# Product Change Notification

Product Change Notification: P-16-012990

50 WAY HYBRID, MALE CAP ASSEMBLY MCON 1.2 / MCP 2.8 TERMINAL SYSTEMS

**Drain Hole Addition**

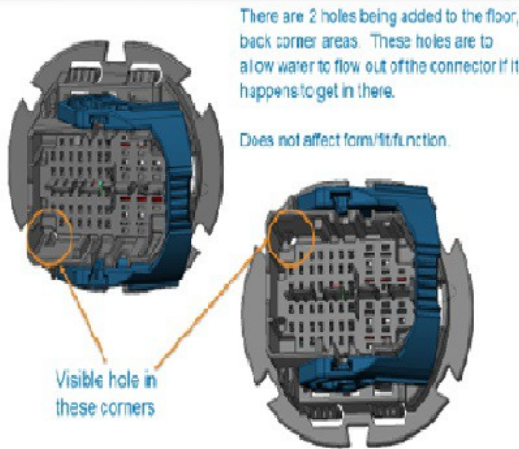
Engineering Change - Current production mold modification to include Chrysler requested changes of adding 2 through (drain) holes and modified panel latches to reduce insertion force. Manufacturing and ship point location unchanged.
